TRANS/WP.29/GRE/2005/19  
18 February 2005

World Forum for Harmonization of Vehicle Regulations (WP.29)

PROPOSAL FOR DRAFT AMENDMENTS TO REGULATION No. 98  
(Headlamps with gas-discharge light sources)

Transmitted by the expert from the Working Party "Brussels 1952" (GTB)

**"Figure D (Class E headlamp for right hand traffic)**

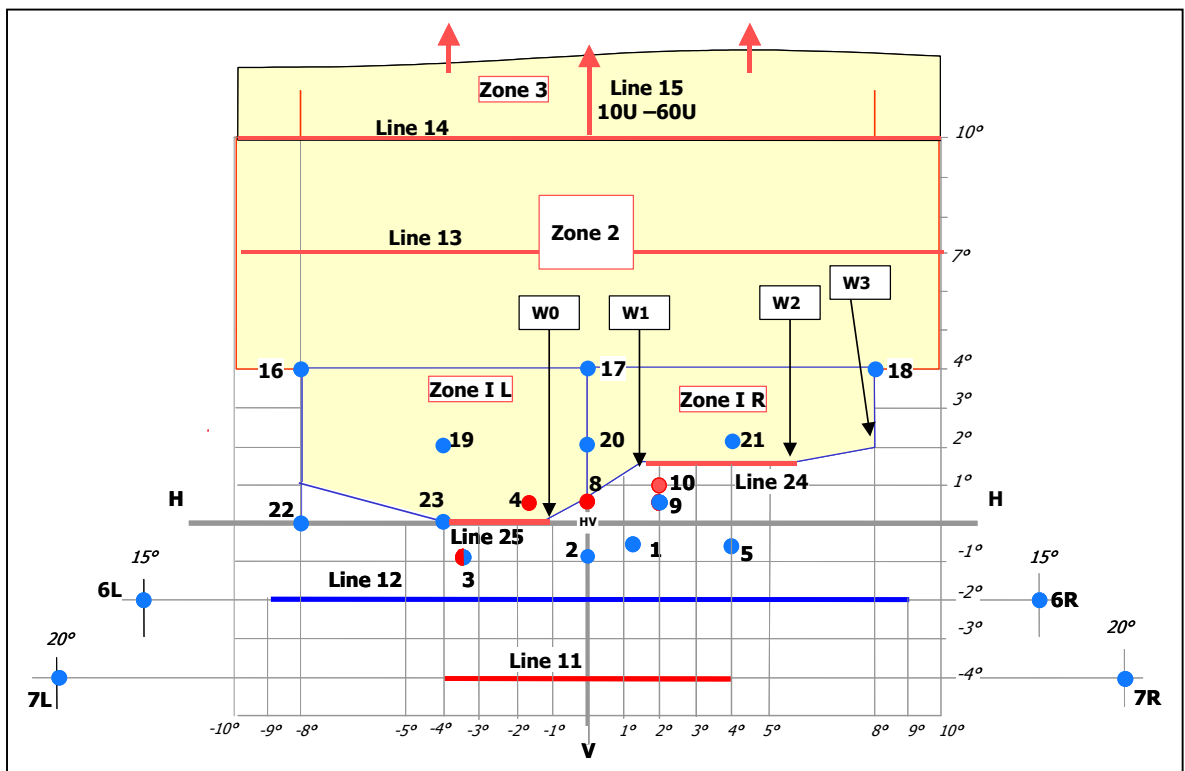
Add at the end of Annex 3, figures D, E, F and G, to read:

**Figure F - Primary driving beam**

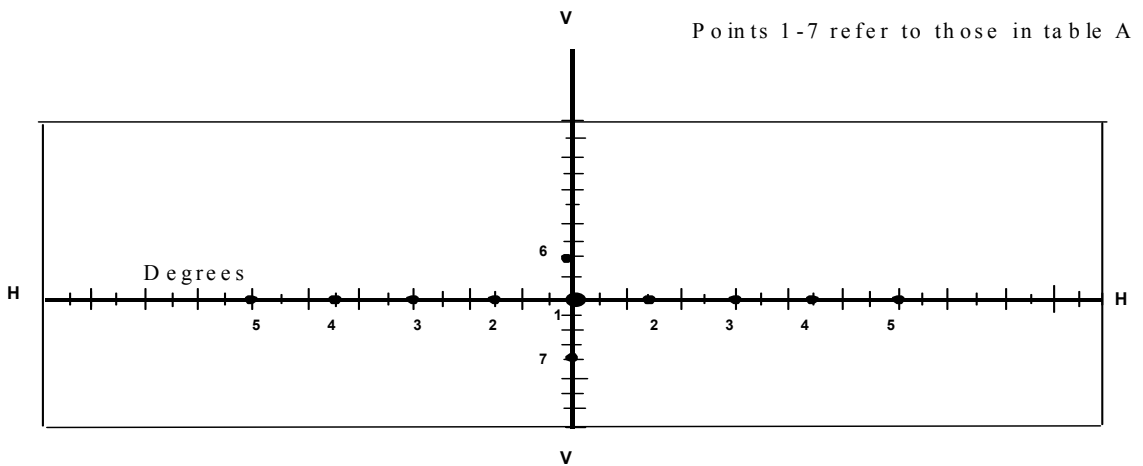
**Table A - Primary driving beam headlamp**

**Refer to Figure F for details of test point positions**

TEST POINT NUMBER	TEST POINT LOCATION	Required illumination in lux	
		Min.	Max.
<b>1</b>	<b>H-V <u>1/</u></b>	<b><u>1/</u></b>	---
<b>2</b>	<b>H-3R &amp; 3L</b>	<b>40.0</b>	---
<b>3</b>	<b>H-6R &amp; 6L</b>	<b>10.0</b>	---
<b>4</b>	<b>H-9R &amp; 9L</b>	<b>4</b>	---
<b>5</b>	<b>H-12R &amp; 12L</b>	<b>1.2</b>	---
<b>6</b>	<b>2U-V</b>	<b>2</b>	---
<b>7</b>	<b>4D-V</b>	---	<b><u>2/</u></b>
	<b>Peak illuminance anywhere in the beam pattern</b>	<b>70.0</b>	<b>180.0</b>

**Figure G - Secondary driving beam**

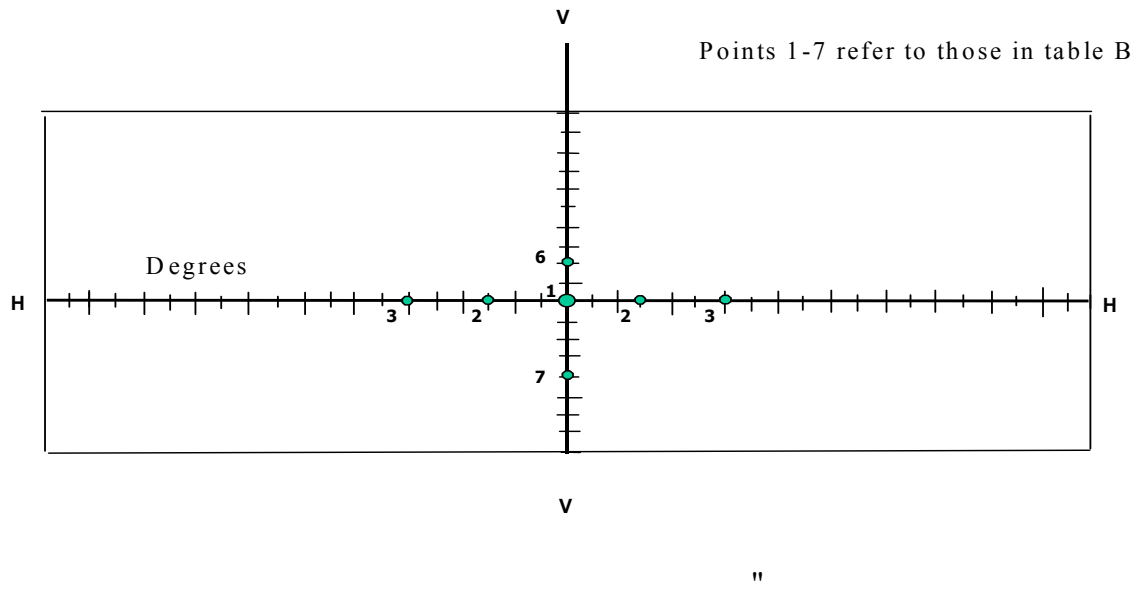
**Table B - Secondary driving beam headlamp operated with a passing beam headlamp or a primary driving beam headlamp**

Refer to Figure G for details of test point positions

TEST POINT NUMBER	TEST POINT LOCATION	Required illumination in lux	
		Min.	Max.
1	H-V 1/	1/	---
2	H-3R & 3L	40.0	---
3	H-6R & 6L	10.0	---
6	2U-V	2	---
7	4D-V	---	2/
	Peak illuminance anywhere in the beam pattern	70	180

**Figure 1**

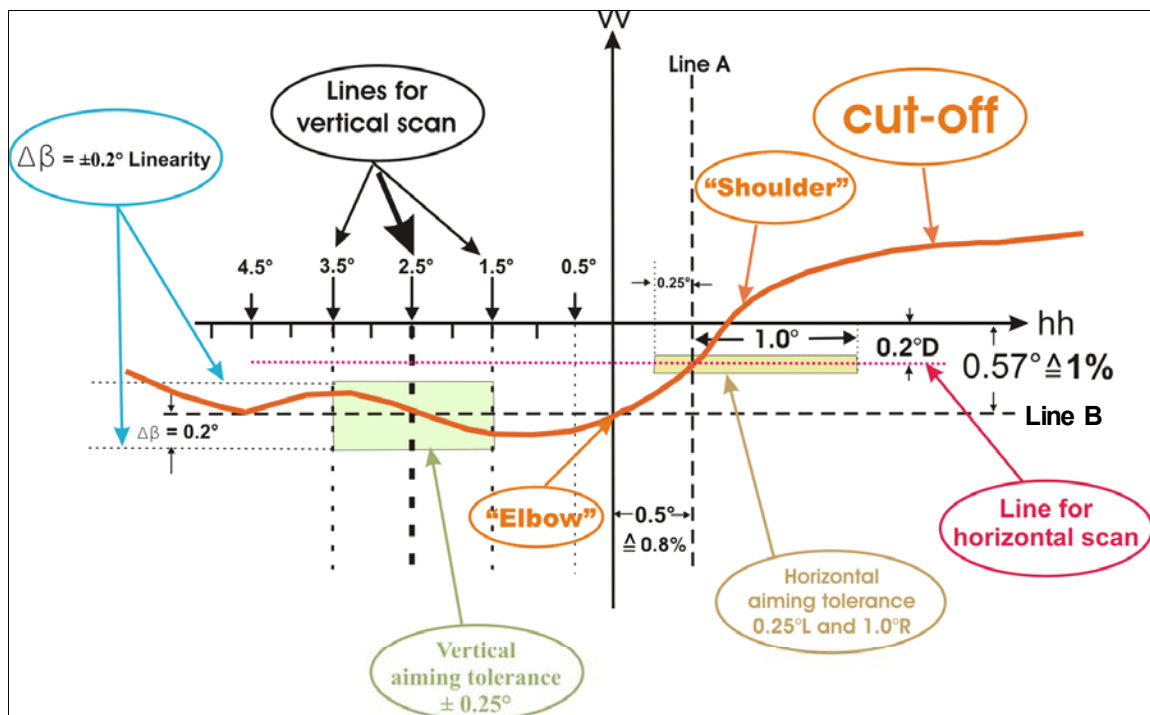
The "cut-off" line shall provide a straight horizontal line between  $1.5^\circ$  and  $3.5^\circ$  to the left of the v-v-line (see Figure 1)(to the right ....)

**Figure 2:** Instrumental vertical and horizontally adjustment - horizontal line scan method

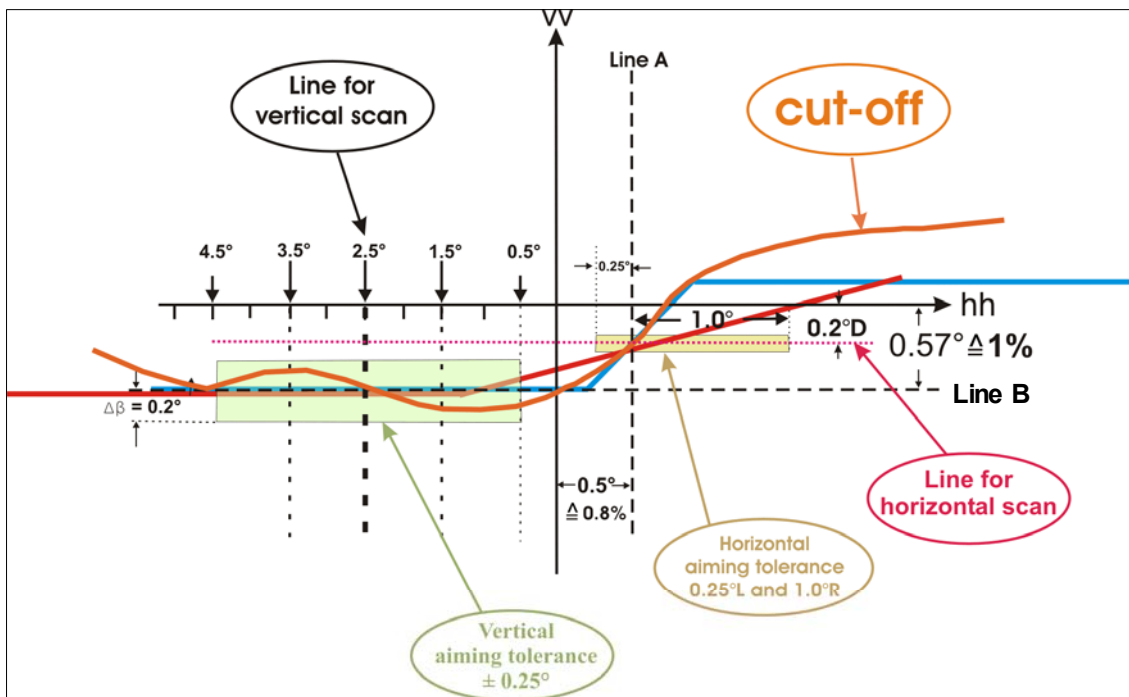
If the "0.2D line" method (Figure 2) is used, a single horizontal line shall be scanned. The minimum gradient found on the 0.2D line shall be not less than 0.08.

**If the "0.2D line" method (Figure 2) is used, a single horizontal line at 0.2° D shall be scanned from 5L to 5R after the lamp is aimed vertically. Determine the maximum gradient as defined in paragraph 4.2. above, shall not be less than 0.08. The maximum gradient positions found on the 0.2D line shall be placed on the V line."**

**Figure 3:** Instrumental vertical and horizontally adjustment - three line scan method

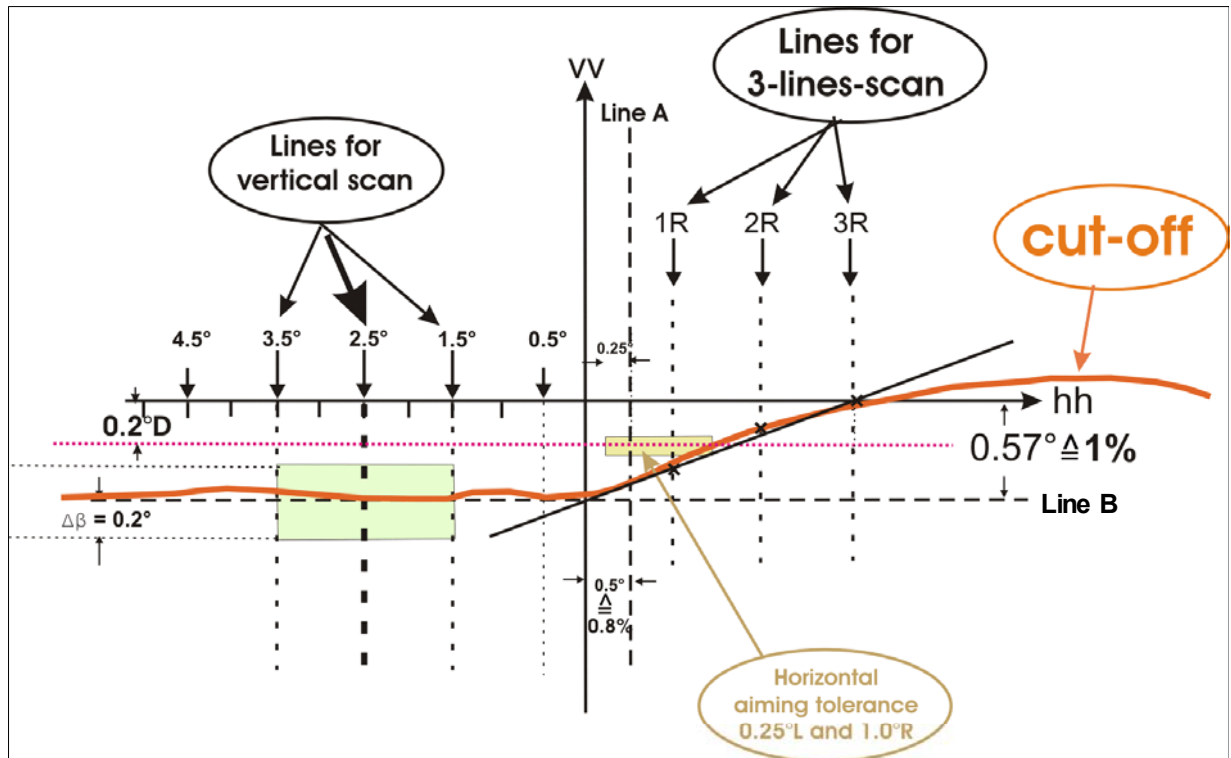
If the "3 line" method (Figure 3) is used, 3 vertical lines shall be scanned at 1R, 2R, and 3R after the lamp is aimed vertically.

If the "3 line" method (Figure 3) is used, 3 vertical lines shall be scanned at 2° D to 2° U at 1R, 2R, and 3R after the lamp is aimed vertically. Determine the maximum

**gradient as defined in paragraph 4.2. above, shall not be less than 0.08 and "A" is vertical angular position. The maximum gradient positions found on the 3 lines shall be used to construct an angled straight line. The intersection of this line and the 0.57D position found while performing vertical aim shall be placed on the V line.**
